Ref: PEG-1155-93M-CN-HI-BOA-LET-ES-10436
Jean Marc Decloquement
Consortium Director
Blocks 277-278,2nd business sector,
Teseen st, Shaker Consultancy Building
New Cairo, Egypt.

Project: Engineering, Procurement and Construction of the New Administrative Capital Monorail and 6th October City Monorail (Contract 93/Metro).

Subject: Comments on shop drawings. // 93M-BOA-NAT-LOT-26138

DRAWING TITLE
6TH OF OCTOBER MONORAIL
GA0101
LINE SEGMENT (L00) Switch Deck

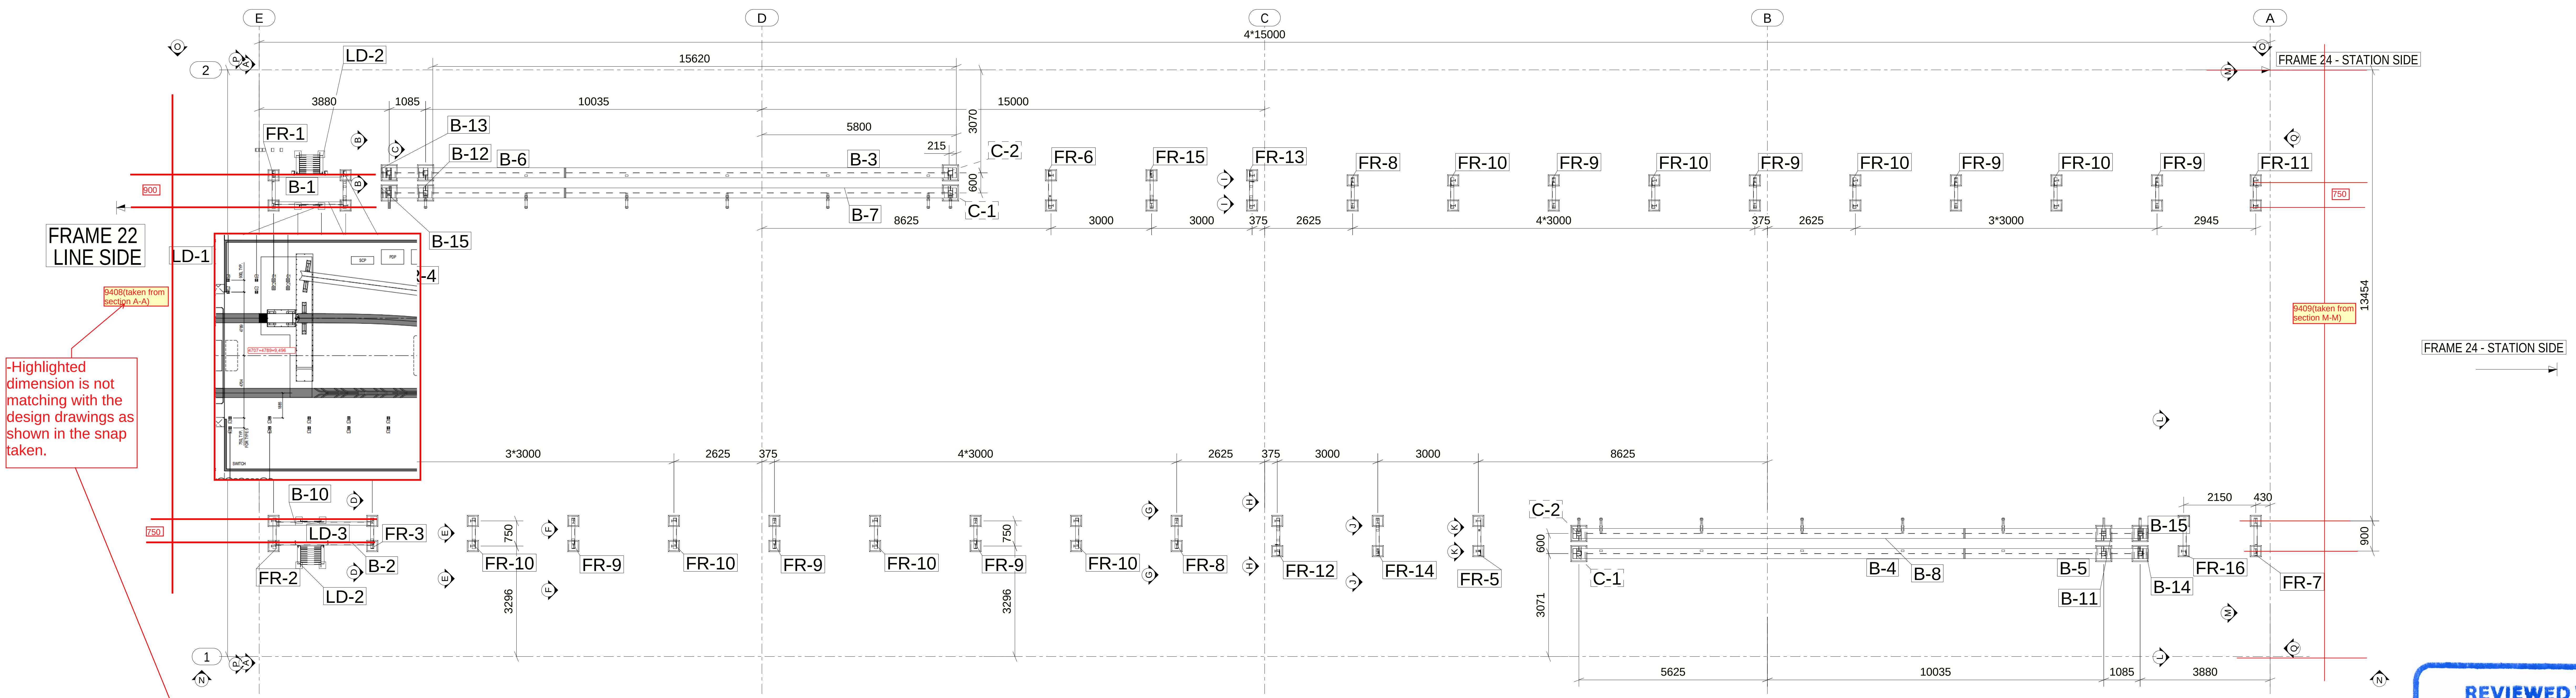
-Please add the Main line and station line axes as they are shown in the design references then refer all the other axes (from A to E) to them.
-Highlighted dimensions are not matching with the design drawings as shown in the snaps taken below.
-Please show the planks on the sections of the GA drawings with their levels.

DRAWING TITLE
6TH OF OCTOBER MONORAIL
SHOP DRAWING FOR LINE SEGMENT (L00)
BEAM : B-1

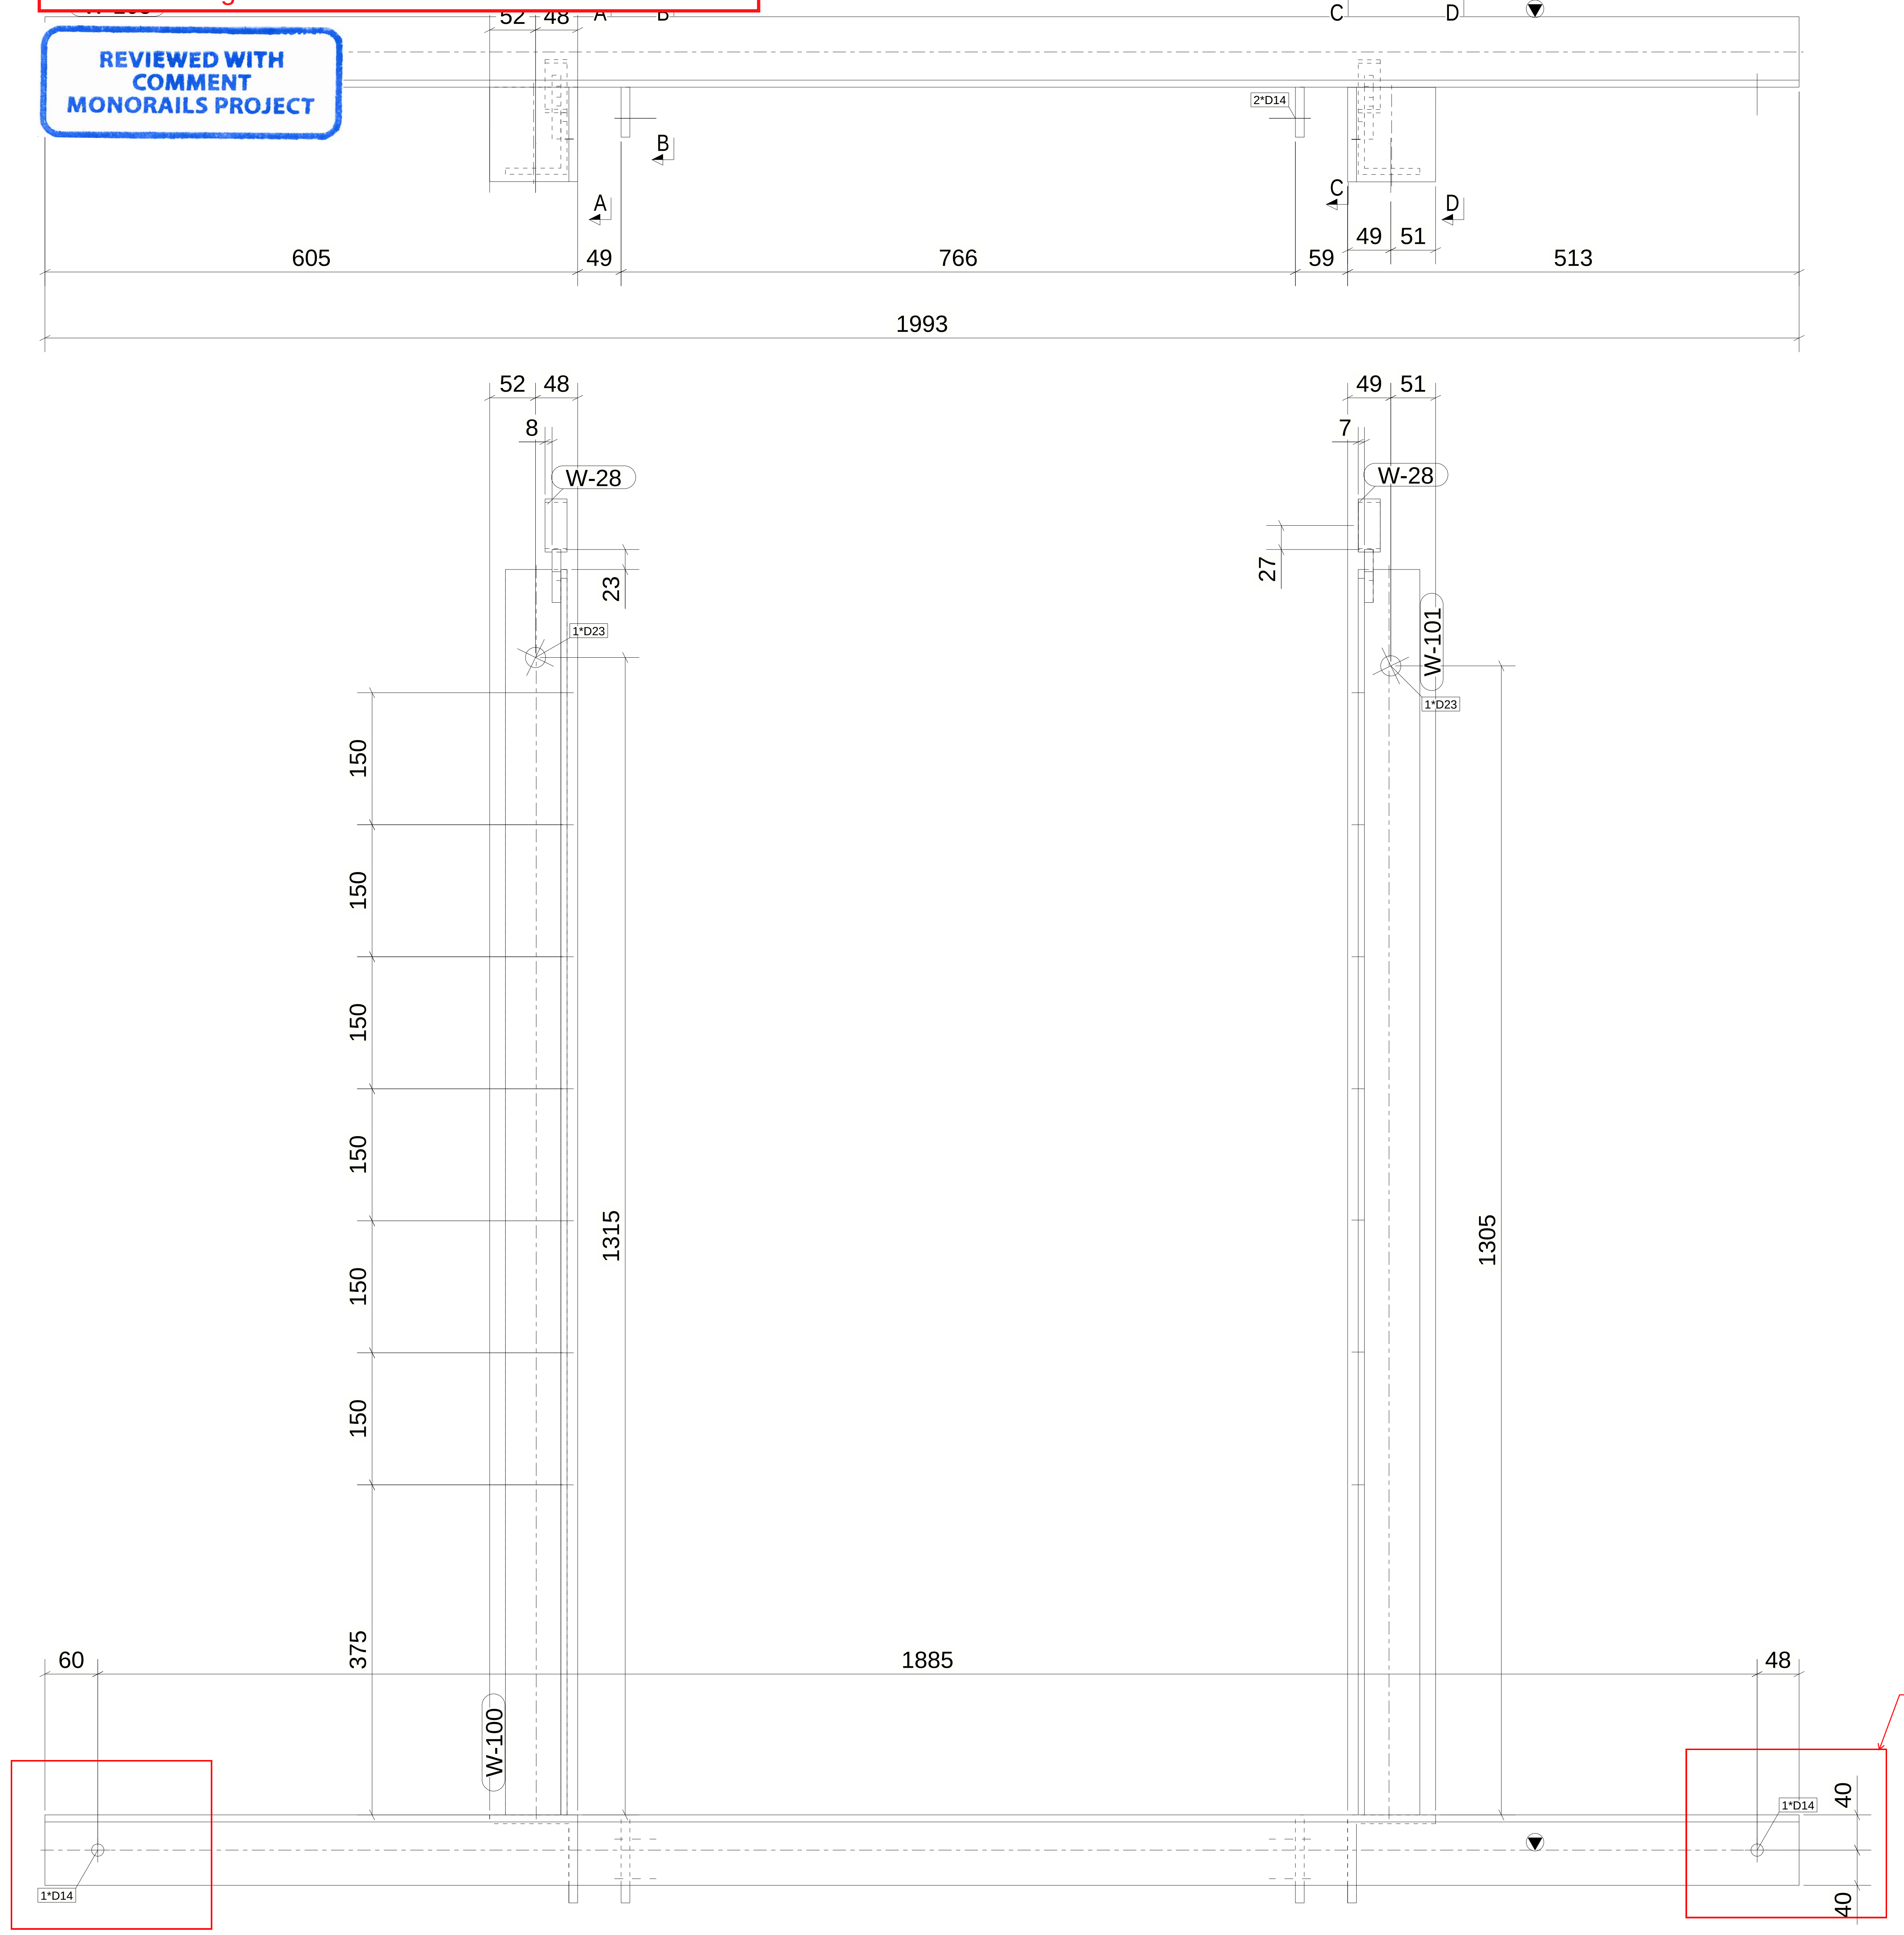
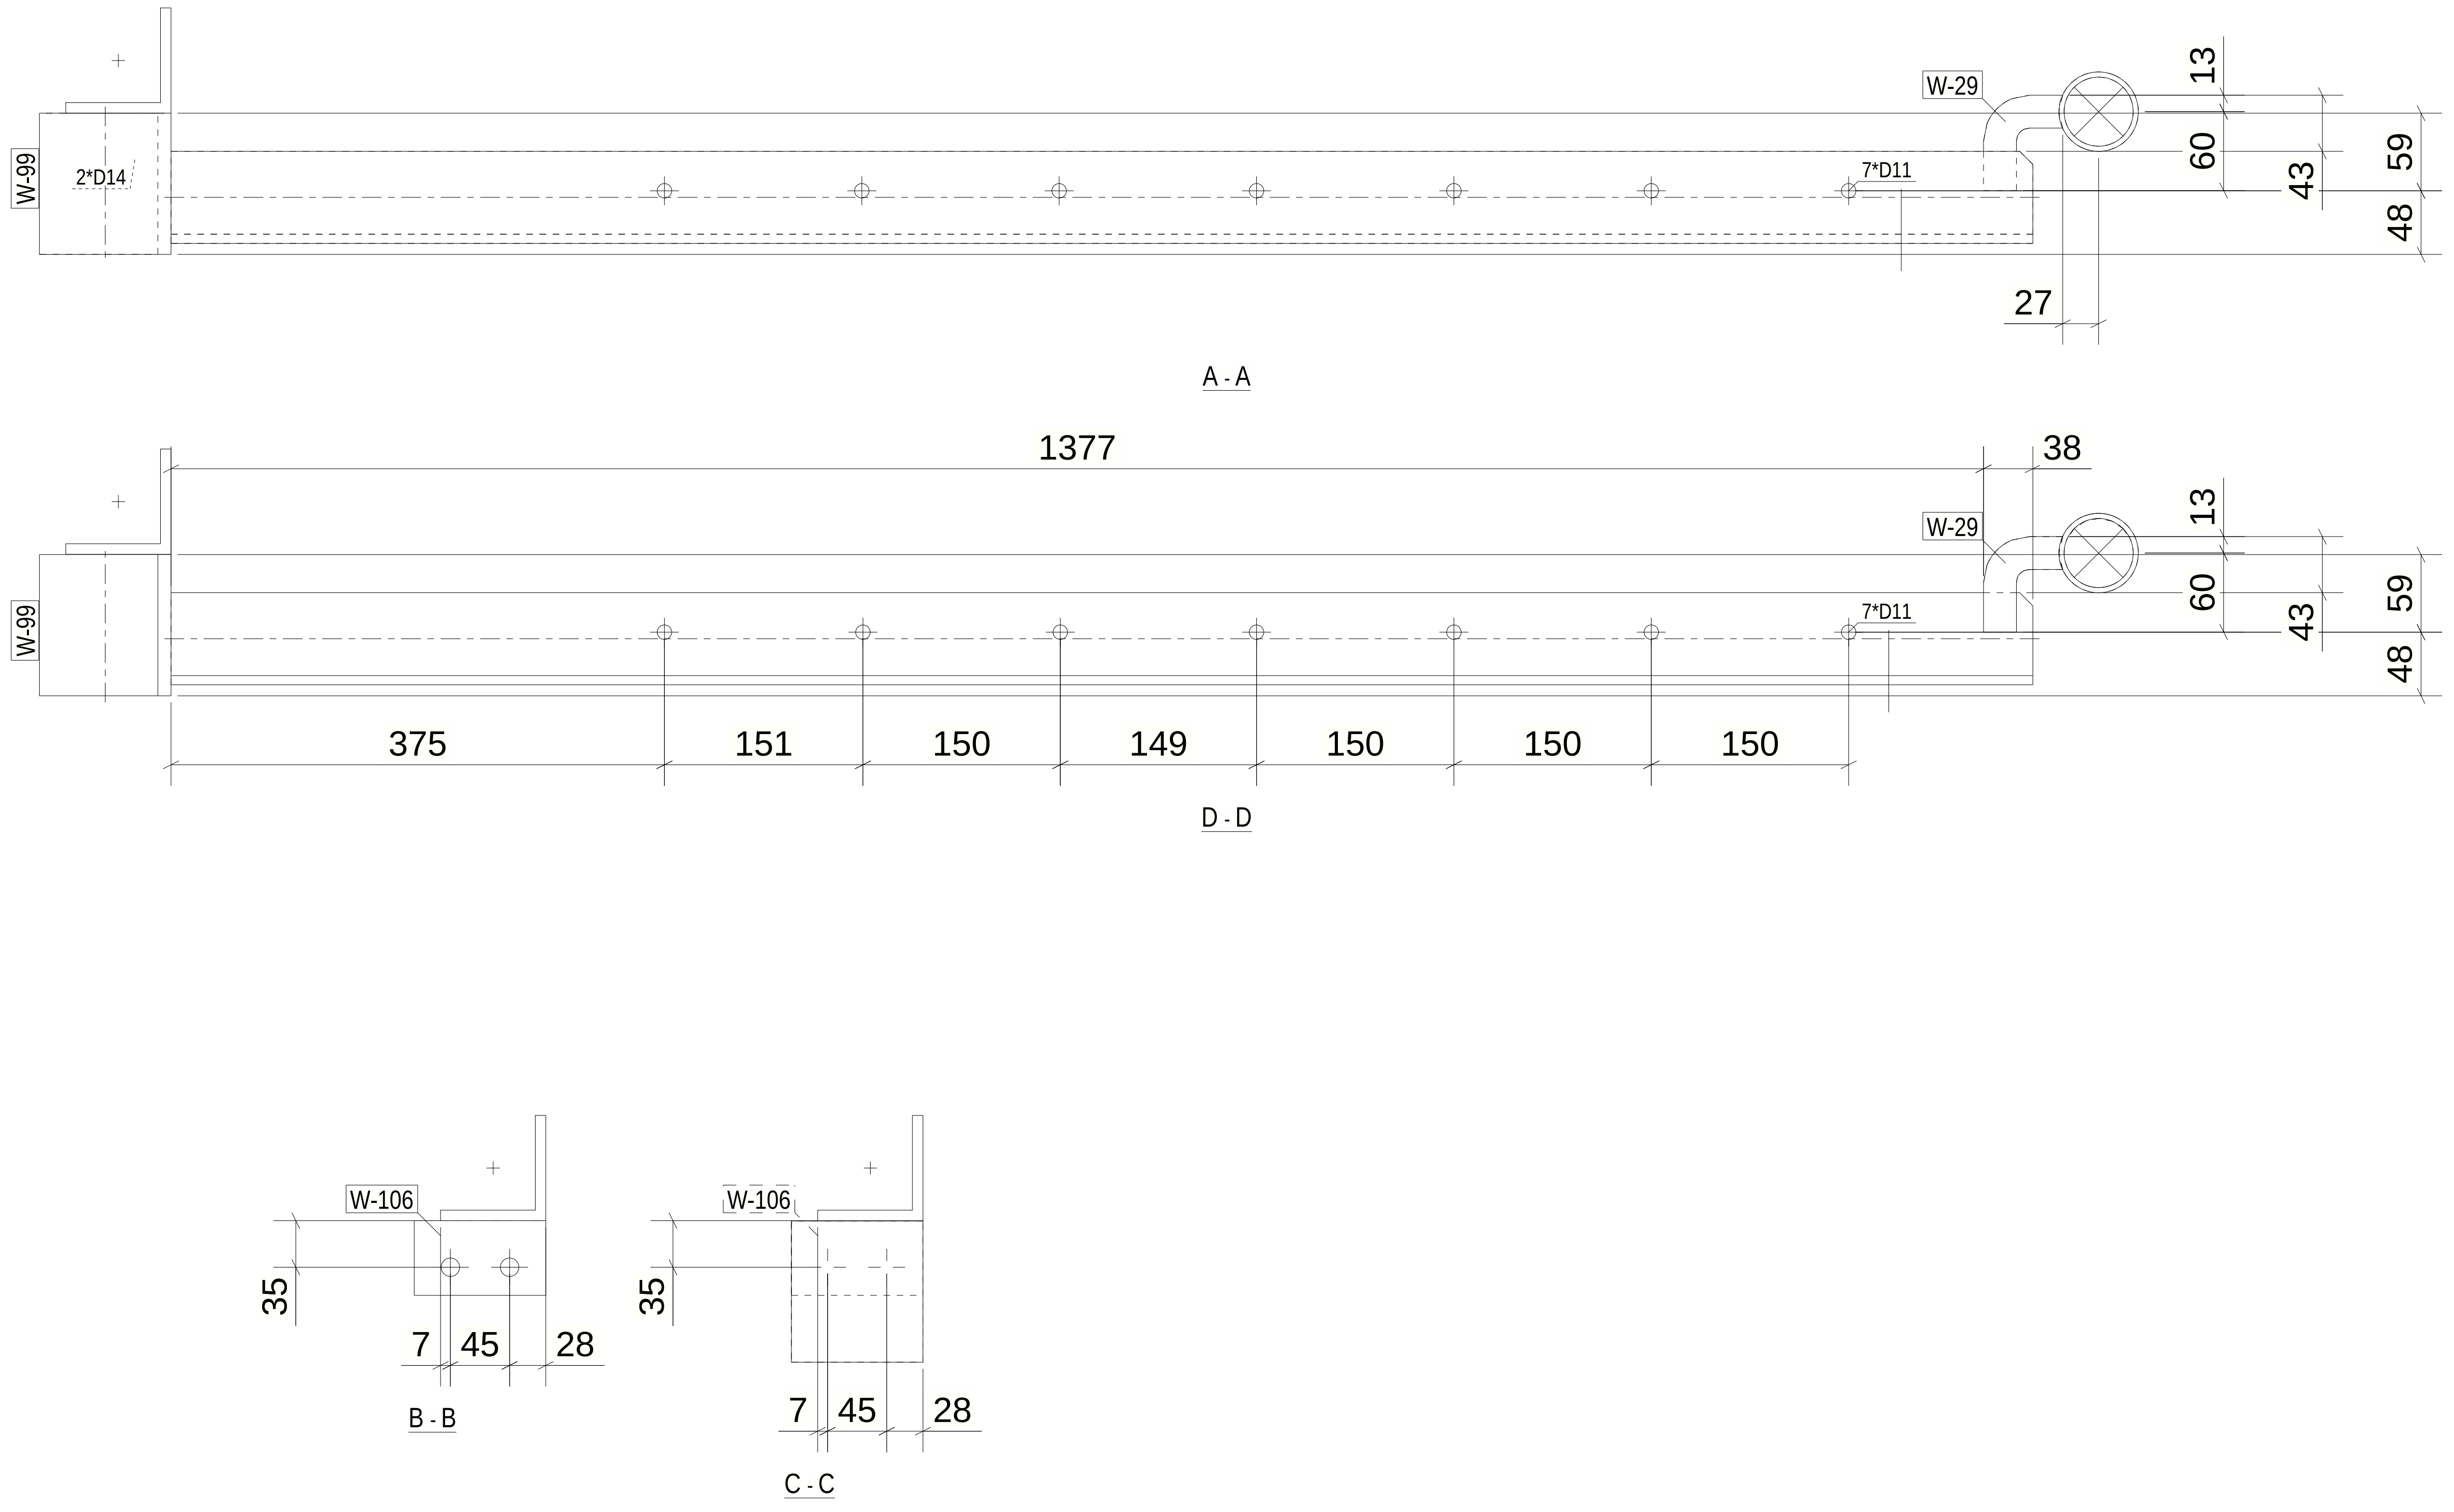
48 40 1*D14 40 The connection is not m the design drawings as 150 75 75 M16 BOLT (FULLY PRETENSIONED, ANGLE PE & ELEV. STD.GA PL w/ 18x40 LSH 25 IPE OR ANGLE POST PER PLAN & ELEV. CONNECTION PLATE 1:5 4
8	93M-0473-ACC-6OL00-DWG-50007-C.	-Same comments as 93M-0473-ACC-6OL00-DWG-50006-C
9	93M-0473-ACC-6OL00-DWG-50008-C.	-Show the bolts in this section and follow the design reference as shown below for the slot sizes.

6TH OF OCTOBER MONORAIL
SHOP DRAWING FOR LINE SEGMENT (L00)
BEAM : B-9

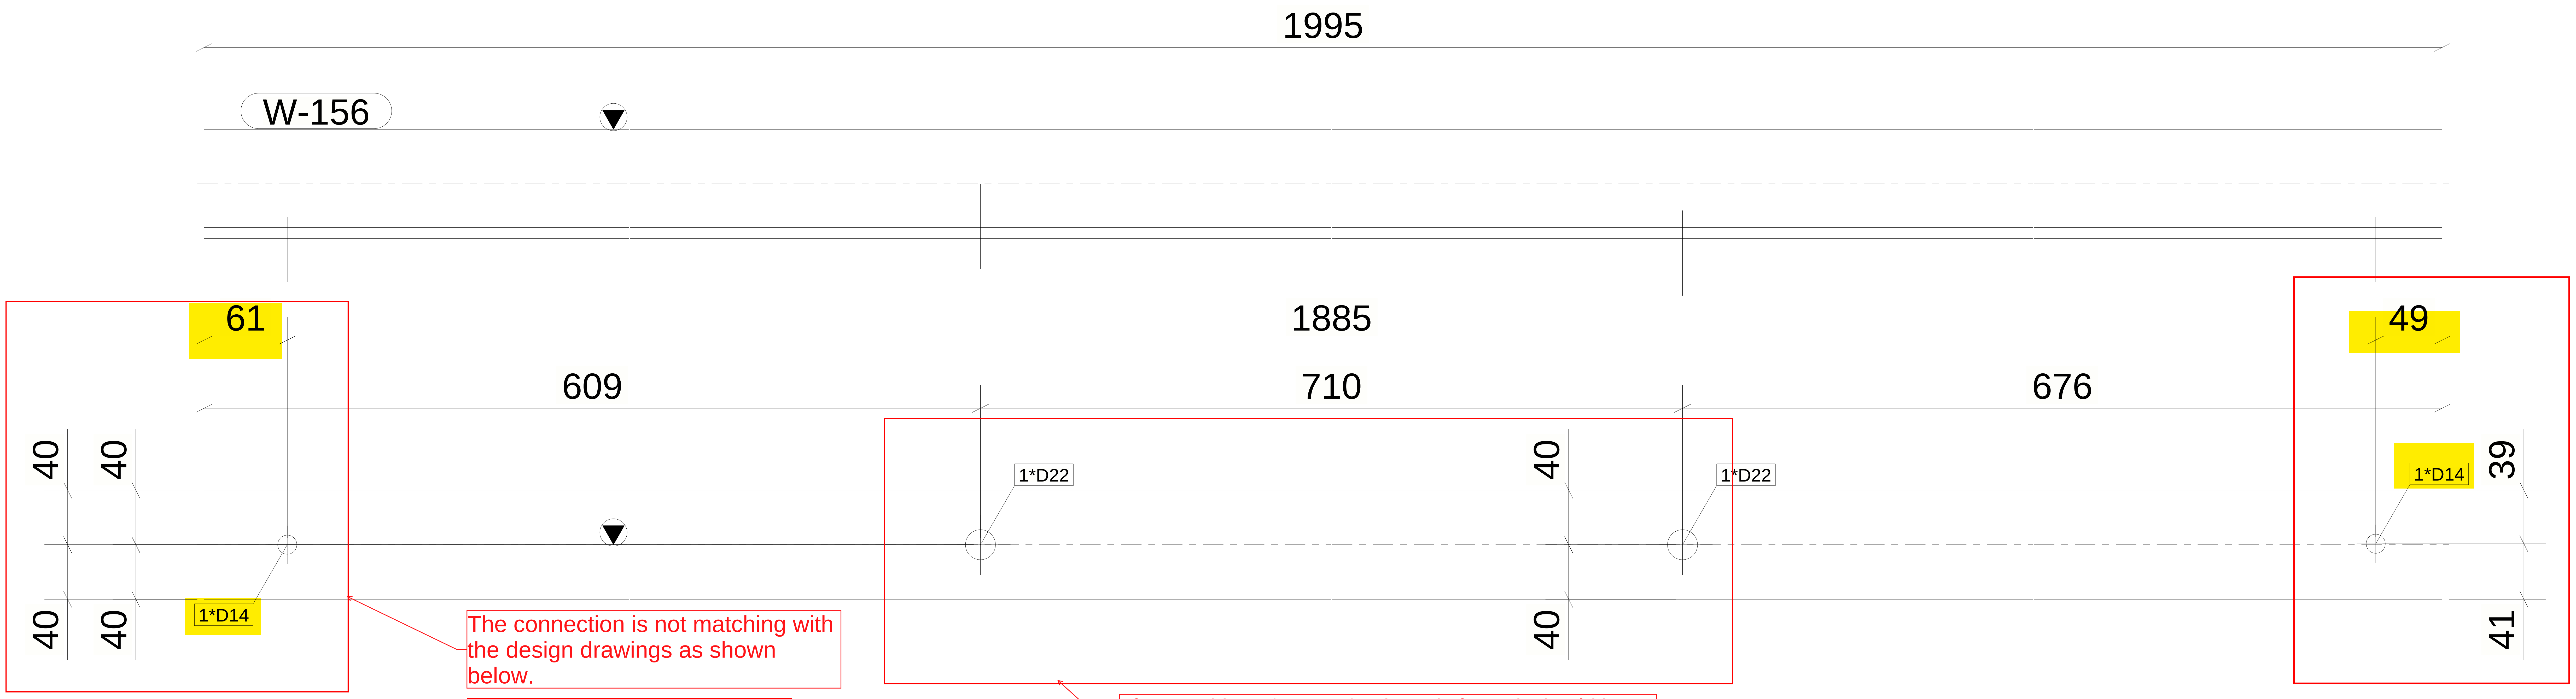
Please add a reference for these bolts as it should be M16 as per design snaps shown below.
